1.0 Introduction

This document has been completed as a response to the request for additional information from South Dublin County Council regarding application reference SD22A/0342, received on 17th October 2022.

2.0 Additional Information - Architectural Elements

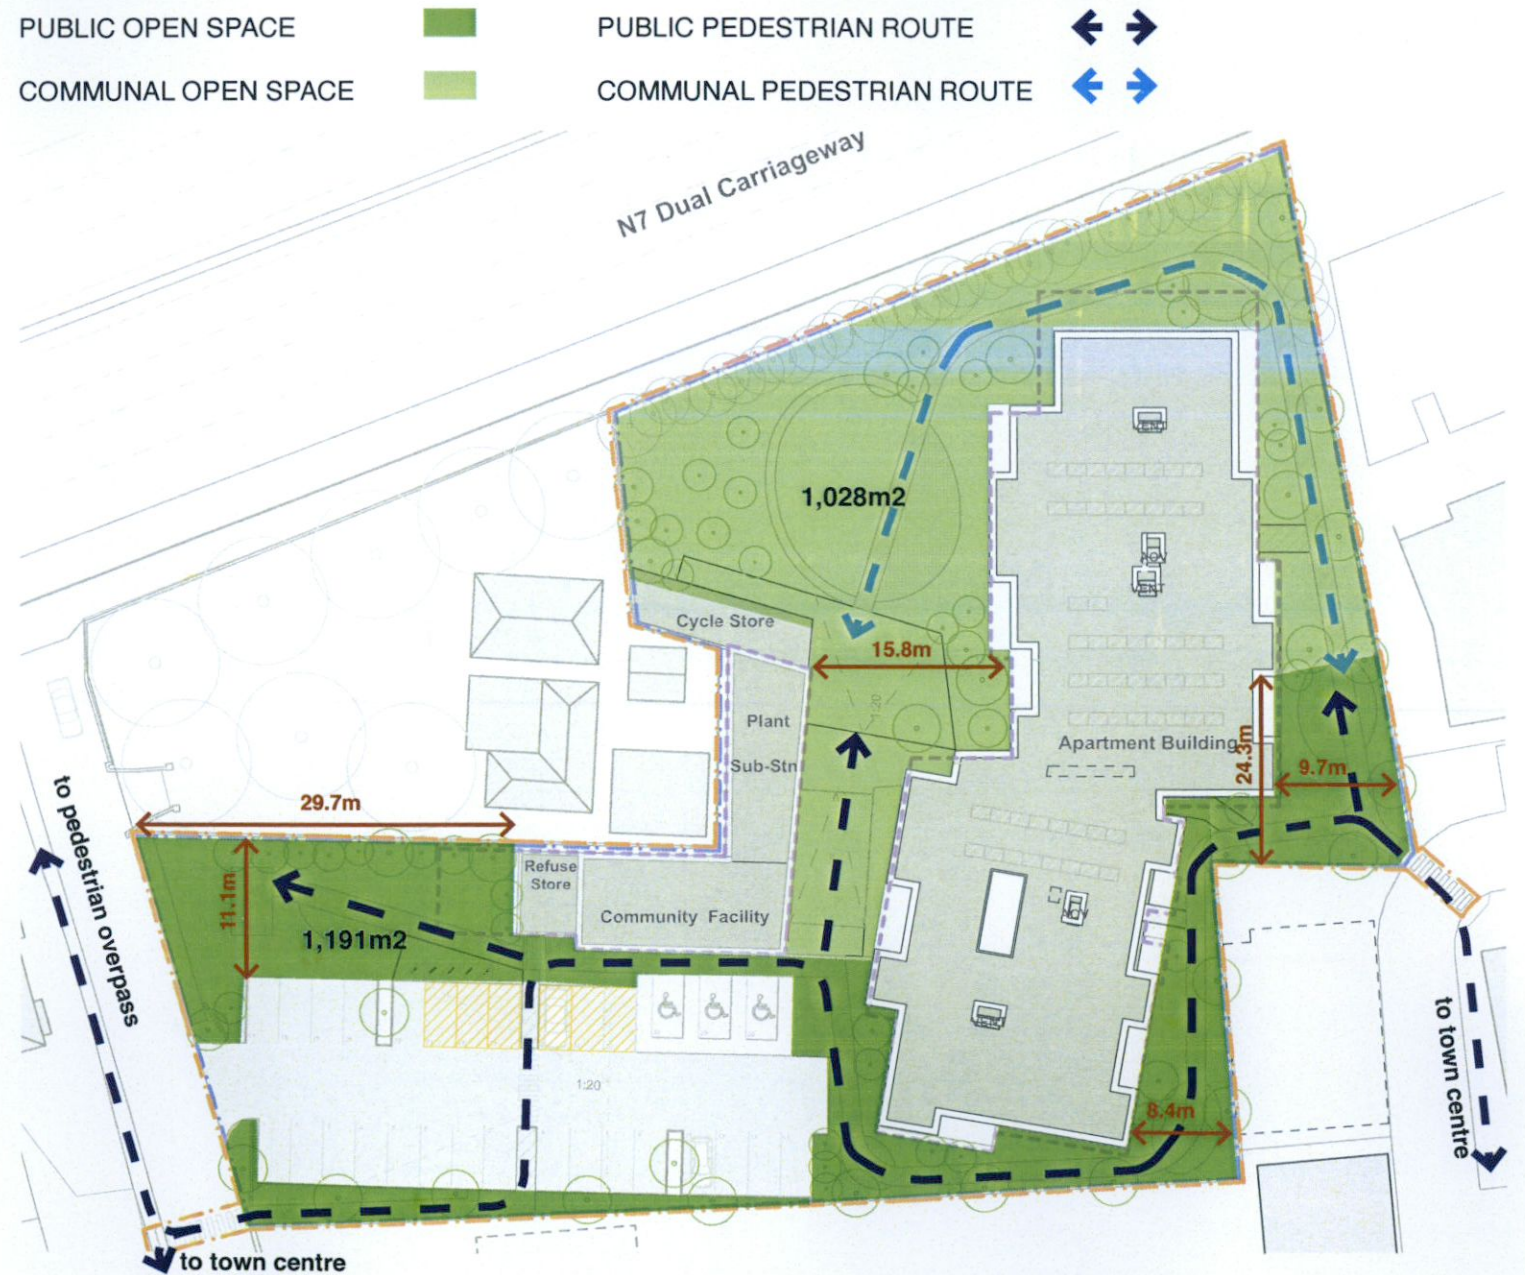
The proposed public open space consists of the pedestrian path and surrounding verges / spaces between the western and eastern pedestrian accesses, and around the southern wing of the proposed building. This is linear incidental space and does not fit the qualitative requirements of the public open space under the County Development Plan. The applicant is requested to provide additional information specifying how 10% of the site area will be provided as Public Open Space to the qualitative standards set out in the DCP and on top of the requirements for Communal Open Space.

In existing residential zonings, a minimum of 10% of the total site area should be allocated for public open space. With a total net developable site area of 0.473Ha, this requires a minimum of 473m² public open space.

The public open space to the front of the site, onto Tay Lane, has been increased to 351m² by moving the bicycle parking to the north end of the plant area to provide a more significant public amenity in this location.

As the layout provides a pedestrian permeability route open for use by the public, it is our view that this should be included within the calculation of the public open space. Public exercise machines have been provided along the route along with bench seating to further satisfy this requirement. Areas along the public pedestrian route provide a large useable amenity space and the diagram below highlights the width of some of these spaces. It is our view that this significantly exceeds the minimum public open space requirements providing a total area of 1,191m².

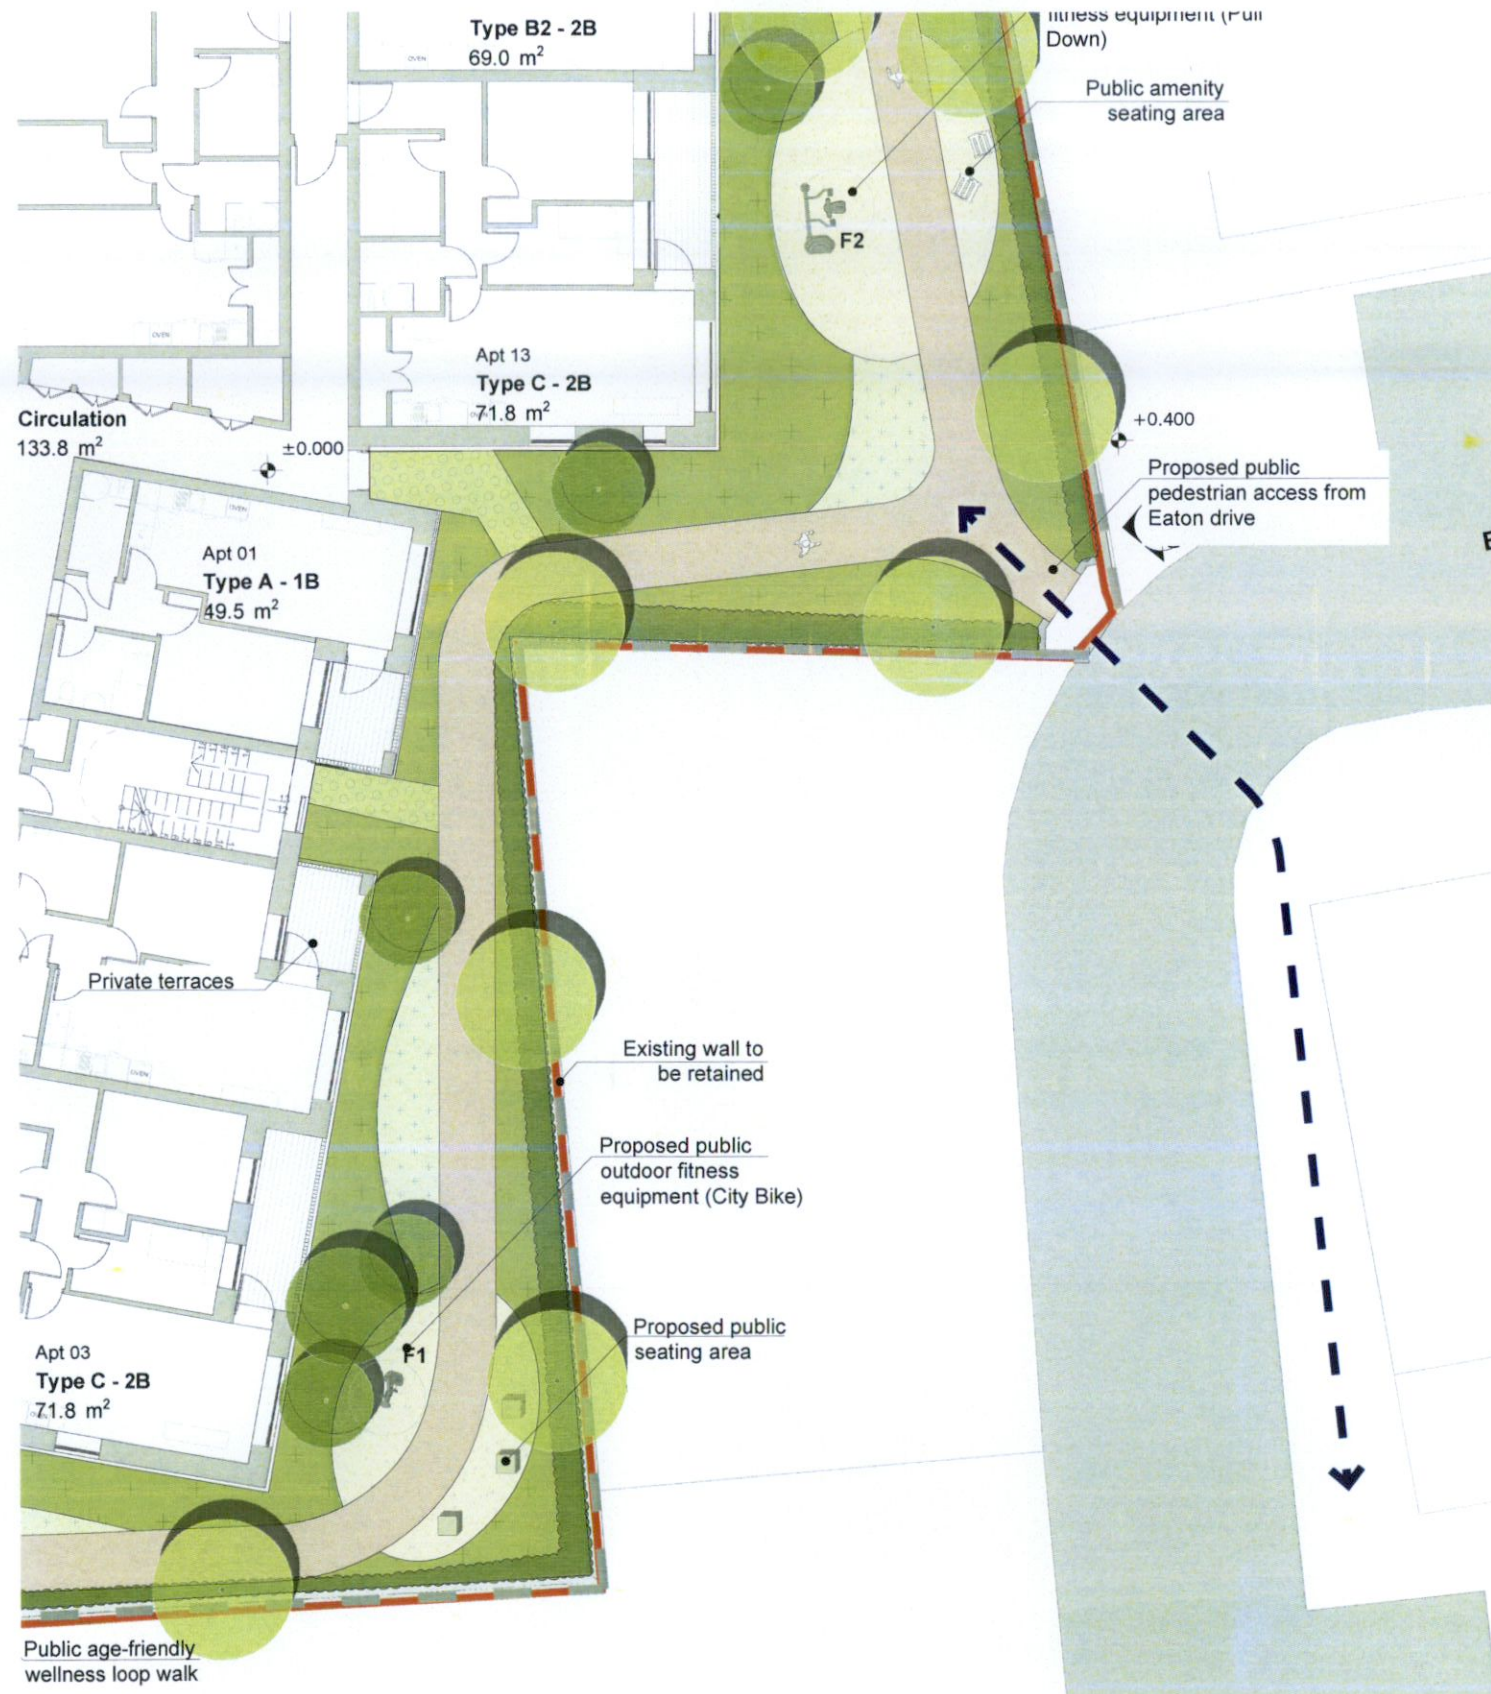
(a) The pedestrian access to the site from Tay Lane is located north of the car park. It is considered likely that pedestrians would simply walk through the car park. The car park should be reconfigured to make some provision along the south of the site for pedestrians, whether it is demarcated and raised footpath through the car park, or a footpath south of the parked cars. (b) The proposed east-west permeability through the site with a pedestrian access onto Eaton Green is encouraged and would contribute generally to a permeable village centre with good pedestrian links. The proposed pedestrian access to the east would open onto an area which may be in private ownership, and has not been taken in charge (though the street itself has been). The applicant should be encouraged to liaise with the Management Company or owner of the Eaton Development and report on progress towards consent for the opening at this location.

The pedestrian access from Tay Lane has been adjusted to provide a crossing point to the south of site, bringing the approach along the southern boundary until it gets too narrow where a second crossing point is located to cross the car park, providing access to the community centre and the apartment building beyond.

The pedestrian access via Eaton Drive will be provided with an entrance point located directly on the site boundary to the public road, taken in charge by South Dublin County Council. Discussions are ongoing the owner of the neighbouring property to provide an improved entrance space in this location but an agreement is not currently in place. However, if an agreement can be made, a further application to alter this part of the application shall be submitted at a later date. In the meantime, the current proposal provides the pedestrian link requested.
